Subject: Recommendation to Deny Zoning Request for Zoning Case NPA-2023-0020.02_106 & 118 Red Bird Lane

*Proposed Zoning Case
NPA-2023-0020.02_106 & 118 Red Bird Lane*

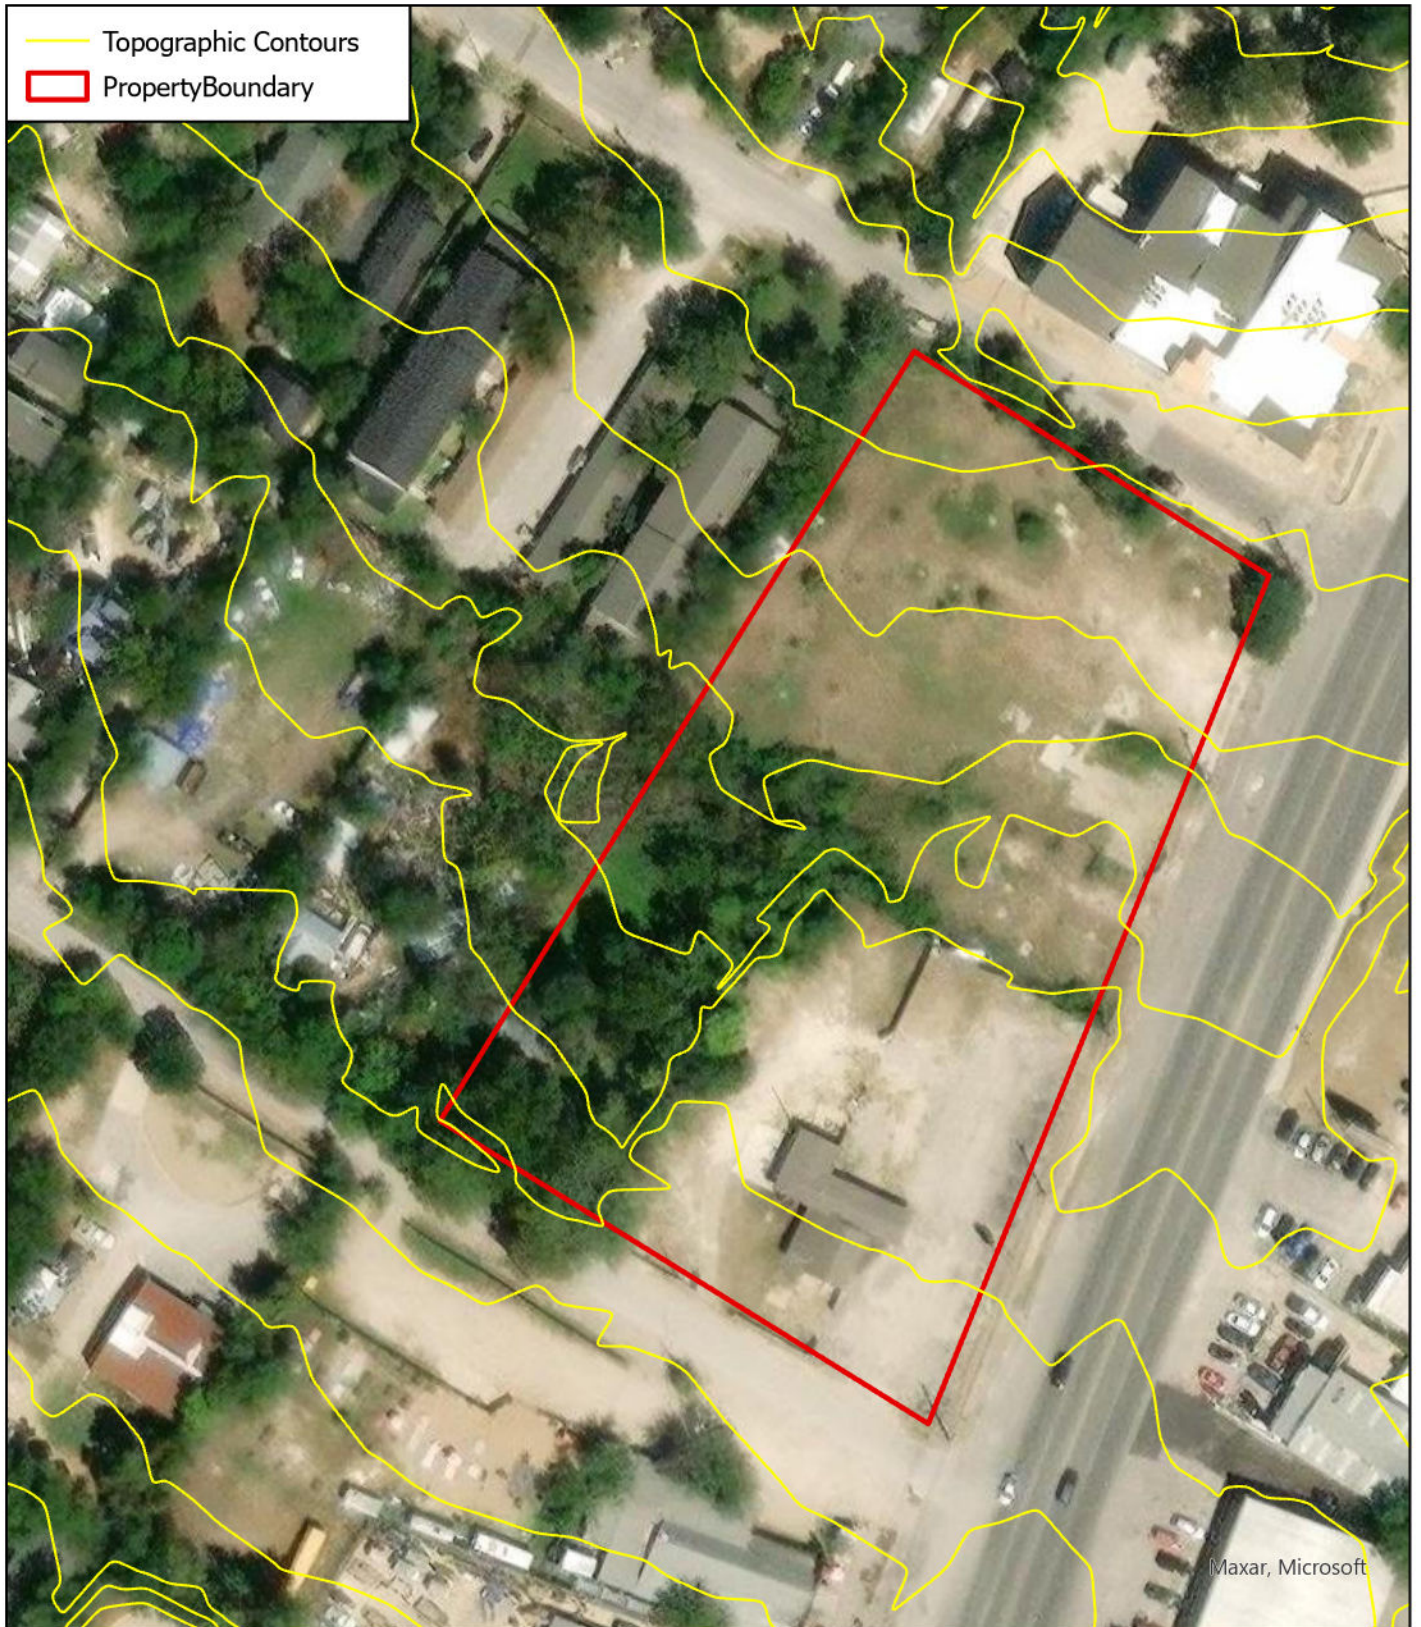
Neighbors have observed an ephemeral stream and spring either adjacent to or traversing the proposed development site. Their observations are consistent with satellite imagery that shows an area of dense vegetation in the southwest corner of the site. Topographic contours are also consistent with the presence of a small stream, as indicated in the attached map.

We respectfully request a recommendation to deny the zoning change until a thorough investigation of the site by an independent environmental scientist is completed. Such an investigation should include an inventory of wetland plants and examination of soils for the potential presence of wetland species that would indicate the presence of a spring.
